June 12, 2015

Our File: 112-3155

**Re: Proposed "The George" Mixed Use Development
377, 385 & 407 Gower Point Road, 397 & 689 Winn Road, and Winn Road Right-of-Way,
Gibsons, BC
Memorandum Regarding Hydrogeological Review Report**

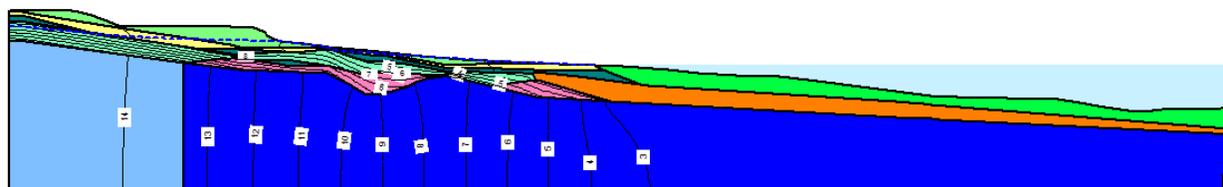
Based on the seepage analyses presented above, a final sensitivity simulation was completed on the Gibsons Aquifer hydraulic conductivity. In this simulation, the Gibsons Aquifer was divided into two zones, as shown in the figure below. The hydraulic conductivity of the Gibsons Aquifer at Town Well #1 was kept at the base case value of 5×10^{-5} m/s. However, starting approximately 10 m up-gradient of BH14-4, the hydraulic conductivity was lowered to 1×10^{-5} m/s, the value used in Run 6 above. As noted above, Run 6 yielded the best fit to the accepted groundwater discharge rate to Howe Sound from the Gibsons Aquifer. The predicted head and groundwater discharge for Sensitivity Run 7 is shown in the table below. This simulation has the best overall fit to the calibration statistics: the predicted head at BH14-4 is within 0.2 m of the target value. The groundwater discharge rate is improved over the Base Case run and also over Run 6, but the predicted discharge is still 2.6 times greater than the value computed by Doyle (2013). The degree of over-prediction of hydraulic head at BH14-3 in Run 7 exceeds the discrepancy in the Base Case and Run 6. The discrepancy between the target and modelled groundwater discharge rate and the head at BH14-3 indicates that, although Run 7 fits the calibration data better than the previous models, even Run 7 has extra conservatism built into it. Therefore, Run 7 was used as the basis of the final sensitivity run.

Parameter	Base Case Seepage Analysis	Sensitivity Run 7: Gibsons Aquifer with 2 K Zones
Gibsons Aquifer West K (m/s)	5×10^{-5}	5×10^{-5}
Gibsons Aquifer East K (m/s)	5×10^{-5}	1×10^{-5}
Head at BH14-4 (m) – target 12.6	10.6	12.4
Head at BH14-3 (m) – target 5.6	6.1	7.4
Discharge to Howe Sound (m ³ /d) – target 220	1,790	560

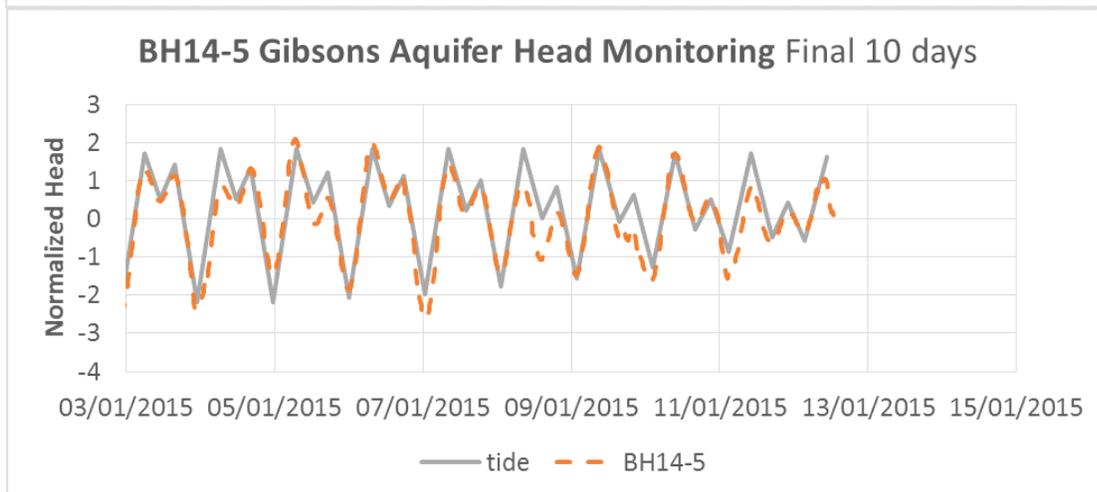
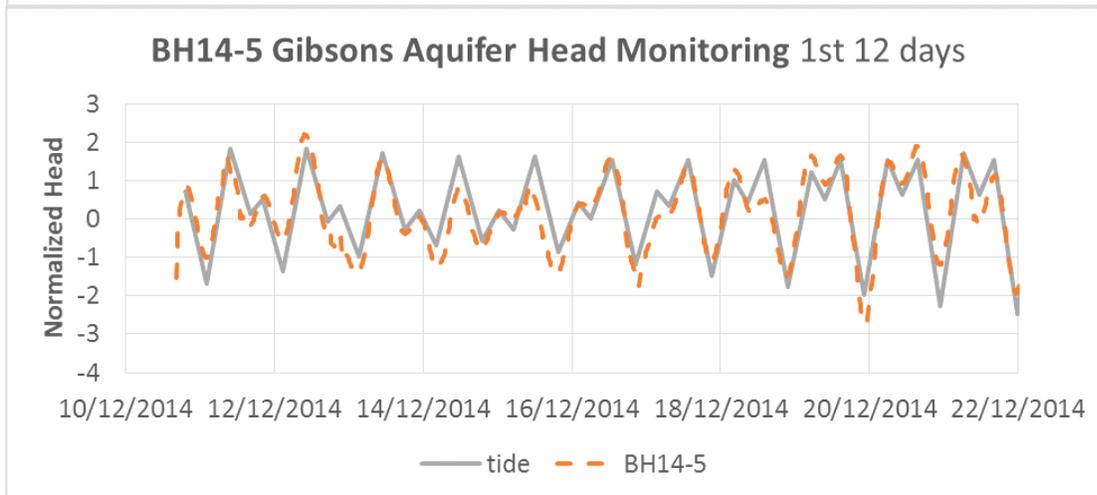
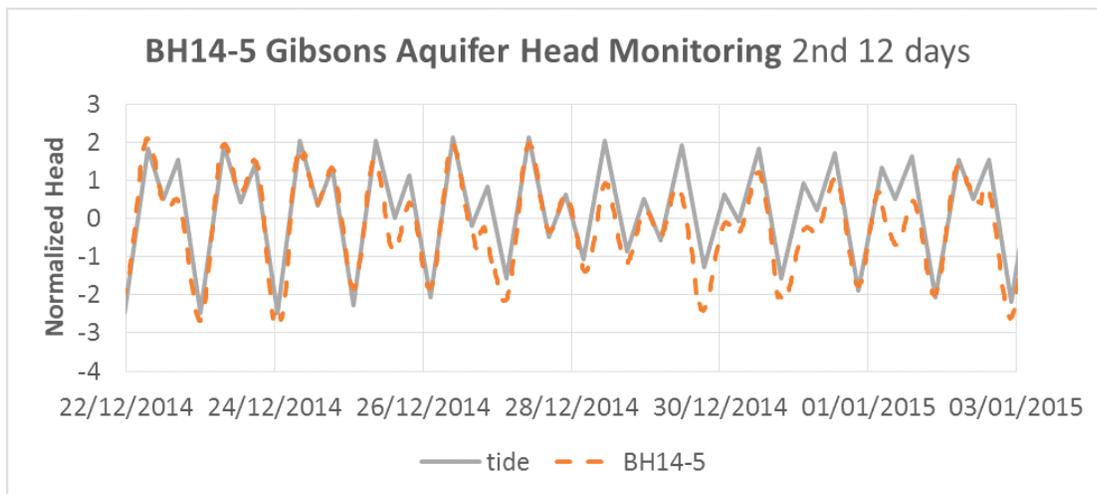
The figures below show the normalized heads at BH14-5 and Howe Sound for the period of monitoring. The heads at BH14-5 were normalized by the calibrated time lag and tidal efficiency for this data set, making use of only the semi-diurnal component of the tidal cycle. The time lag for pressure propagation between Howe Sound and BH14-5 is approximately 30 minutes, and the tidal efficiency (dimensionless) is 0.21. In this analysis, the hydraulic conductivity of the Gibsons Aquifer is assumed to be 2.2×10^{-4} m/s, the value calibrated by Doyle (2013) to the groundwater model, and the aquifer thickness is assumed to be 70 m, based on the hydrostratigraphic section in Figure 9 of Doyle (2013). With these assumptions, the storativity of the Gibsons Aquifer between BH14-5 and Howe Sound is computed to be 0.069 using the tidal efficiency. The tidal efficiency is a more reliable parameter than the time lag to use in this analysis, because the only the high and low elevations of Howe Sound ocean tide were used in the calculation of time lag. A storativity of 0.069 indicates an unconfined component of the head perturbation response at this well. In other words, we can see that the tidal pressure perturbation travels rapidly within the Gibsons Aquifer in the southern portion of the property and that the reduction in the amplitude of the

tidal signature is consistent with that of a partially or fully unconfined aquifer. Assuming that the aquifer is confined results in an estimate of the (confined) specific storage of $3 \times 10^{-3} \text{ m}^{-1}$, which is approximately two orders of magnitude higher than a typical value for a sand and gravel aquifer. An unconfined or partially confined aquifer condition between BH14-5 and Howe Sound is consistent with the boring logs in this area, which confirm an absence of a dense confining till in several locations along the foreshore and a thinning of the Low-K Gibsons Aquitard.

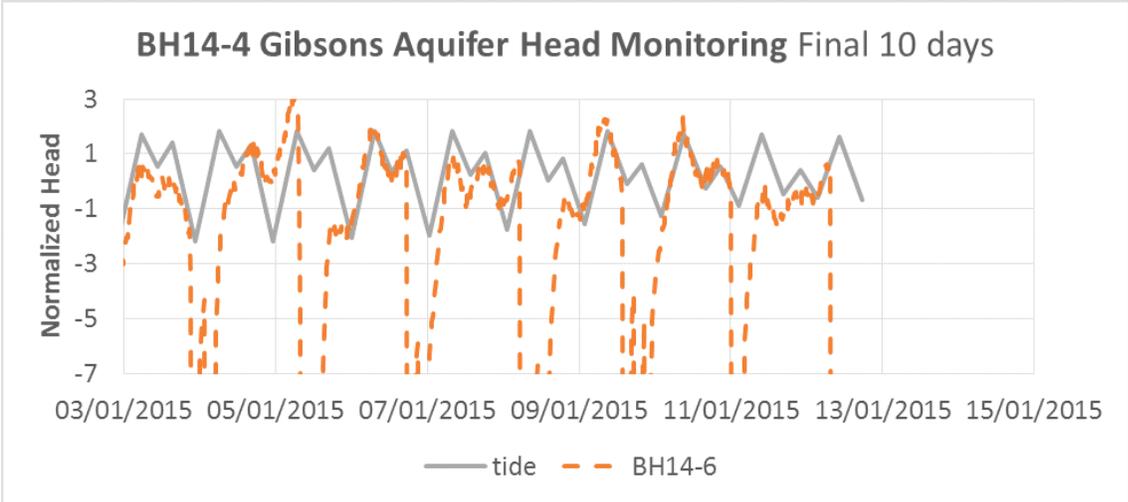
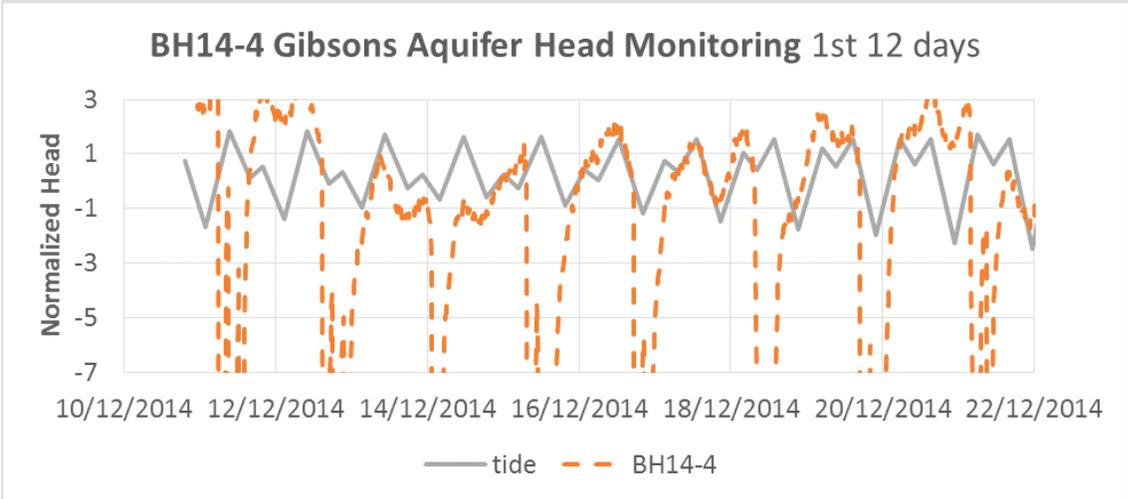
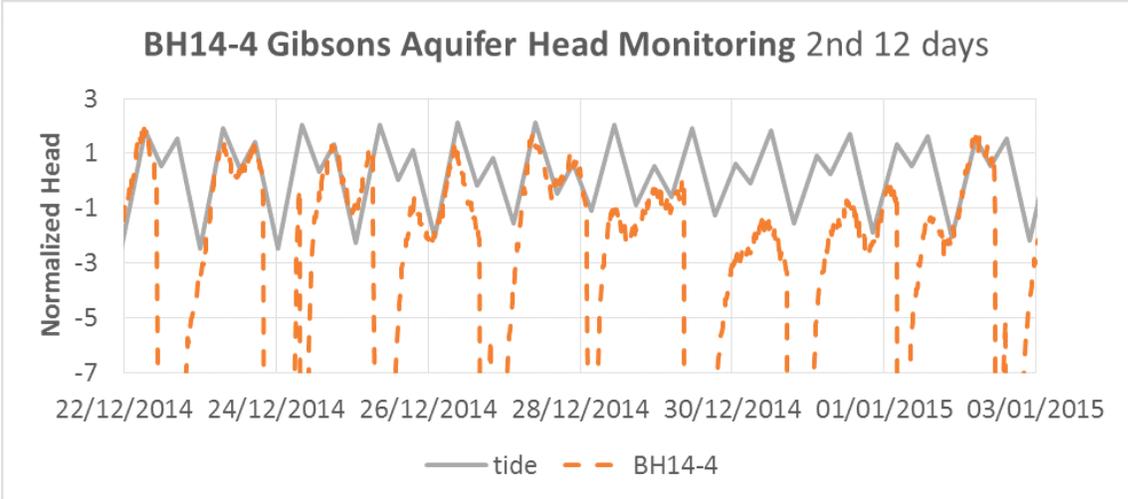
Although the water table fluctuations at BH14-4 are dominated by the pumping of Town Well #1, a weak tidal signature is evident at this location. The hydraulic diffusivity analysis of Erskine (1991) was applied to this well, and the results are illustrated in the figure below. Even at this location, where the Gibsons Aquitard is clearly present in the boring log, the tidal signature indicates only partial confinement between the well and the ocean. At this well, the storativity computed from the tidal efficiency is 0.26, or an estimated specific storage of 3.7×10^{-3} m⁻¹. These values also indicate an unconfined aquifer condition between the ocean and well. The figure below shows that not all of the factors controlling the piezometric head at BH14-4 are captured by the simple tidal analysis using only the semi-diurnal oscillations. Nevertheless, the data points indicates that partially unconfined conditions occur between BH14-4 and Howe Sound.
